Determination 2015/009

Regarding the code-compliance of a window in a proposed shower enclosure of a new house at 591 Paerata Ridge Road, Opotiki

Figure 1: Shower sill detail (not to scale)

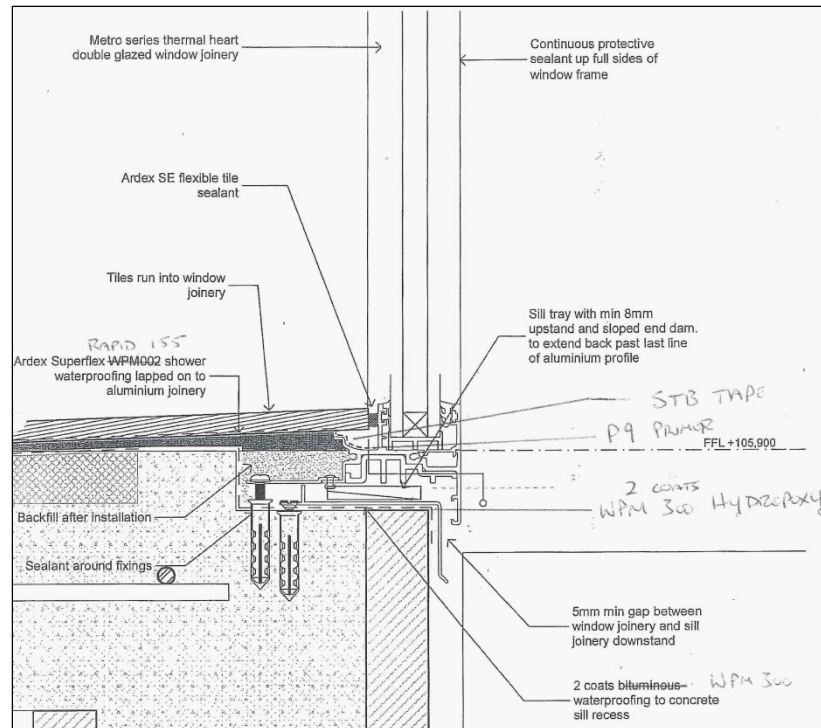
2.2 On 6 November 2014 the contractor sent a request for further information, noting that the contractor did not consider the proposed details would comply, and there was 'no evidence/information to qualify or substantiate how the window/door and associated construction details will be made impervious and easily [c]leaned'.

2.4 The contractor responded on 12 November 2014, noting that it did not consider the proposed details would comply with clause E3.3.4 or E3.3.5 and requesting a statement from the manufacturer or supplier of the window confirming that the window is designed for the intended use and will comply. The contractor also requested further information and clarification in reference to the performance requirements of clauses E3.3.4 and E3.3.5 as follows:

- How allowing water to drain through the window/door system will meet the requirement for impervious and easily cleaned; taking into account:
 - By being impervious, no passage of moisture/water is allowed.
 - Possibility of the water is trapped (sic) within the floor rebate and cannot be drained. What is the likelihood?
 - How the drainage system will [work] with [a] build-up of soap/[grit] from normal use?
- How the system can comply with 'easily cleaned' provision of the code when allowing water to pass through gap and space that are not accessible

during normal maintenance. What is the impact of soap or chemical in the water on the drainage system so that the whole system can continue to perform its function for at least 15 years?

- ‘There is no dispute with regards to requirements of building code clause E3.3.6. What is in dispute is compliance with E3.3.4 and E3.3.5 and how compliance can be demonstrated ...’

- It was accepted that in this case the consequences of failure and damage are ‘low/unlikely’. The determination should consider whether the same arrangement but with a timber floor or timber frame construction would comply, as the architect has submitted that the argument should be considered whatever height the window sill is above floor level.

- The window is not as easy to access and repair as most shower screens. There is no evidence as to how the window is fit for the purpose in terms of being impervious and easily cleaned.

2.3 The architect responded on 11 November 2014, providing a window sill detail drawing and noting that:

The silicone seal is the same seal relied on for the junctions at tile corner joints. The water proofing to the floor and walls will be sealed on to the aluminium joiner. If the seal were to fail the moisture would be taken out via the [sill] tray to the exterior – as shown in [the attached drawing].

2.5 The architect emailed the contractor on 12 November 2014, noting that the waterproofing under the bathroom tiles will extend onto the sill joinery. This was similar to 'standard' waterproofing details used at floor/wall junctions in tiled shower cubicles where a waterproofing membrane is used to prevent the passage of water. The architect also noted:

- Should both the flexible sealant between the tiles and the joinery and the waterproofing layer to the joinery fail, a small amount of moisture would reach the sill tray which itself drains to the exterior.

- If the moisture failed to track onto the sill tray, it would reach the bituminous waterproofing layer applied to the rebate in the concrete slab, which would also drain to the exterior.

- Should moisture penetrate at the sill fixings, there may possibly be a slight dampening of the concrete block/slab, but this will always be less than dampening caused by water running down the block after rain. The durability of the building (concrete block/slab) was not adversely affected by moisture penetrate.

- It was unlikely that moisture penetrating the joint would be soap or chemical-laden. If it was, the seal between the tiling and the window frame and the waterproofing membrane were designed to withstand their effects.

4.2.5 I am of the view that the relevant surfaces in this case satisfy the requirements of Clauses E3.3.4 and E3.3.5.

- 4.3.1 The performance requirement of Clause E3.3.6 is to avoid the likelihood of internal moisture being able to penetrate behind linings or into concealed spaces. This is to prevent fungal growth or the accumulation of contaminants on building elements, and to prevent damage to building elements. I consider the floor/window junction works as a system and that Clause E3.3.6 applies to the system as a whole.

- 4.3.2 The shower tiling includes a waterproofing membrane that will direct any moisture to the condensation channel in the window. Any moisture breaching the sealant at the tile to window junction would also fall into this channel. The channel is designed to typically collect any condensation that runs down the inside of the glass and frame, with holes in the channel that direct the water to the outside; as such it provides an adequate outlet for water that may penetrate the sealed junction or the tiles.

- 4.3.3 Should the primary seal fail there are three mechanisms that will direct any internal moisture to the exterior:
- the purpose-made condensation channel to the window sill

- the sill tray under the window
 - the waterproofed rebate in the concrete slab.
- Any other failure of the window’s waterproofing performance (i.e. failure of mitre junctions in the aluminium or the glazing gaskets) would lead to the same drainage mechanisms being brought into play.

- 4.3.4 There are no building elements likely to be at risk of damage if the primary seal fails. The building elements concerned are durable and would not be adversely affected by the levels of moisture likely to arise from the expected use of the shower.

- 4.3.5 It will be important to ensure the manufacturer’s instructions are followed in relation to the correct installation of the shower membrane and the primary seal, etc. It is also important to ensure that neither the shower membrane nor the primary seal will adversely affect the drainage from the condensation channel, i.e. that neither element restricts or reduces the proper drainage from the channel.

- 4.3.6 Notwithstanding these considerations, in terms of the plans provided with the consent application and additional information received from the applicant as part of this determination, I consider there is sufficient evidence to establish on reasonable grounds that the proposed building work will comply with Clause E3 of the Building Code.

- 5.1 In accordance with section 188 of the Building Act 2004, I hereby determine that the detailing to the window of the proposed shower enclosure will comply with Clause E3 of the Building Code.
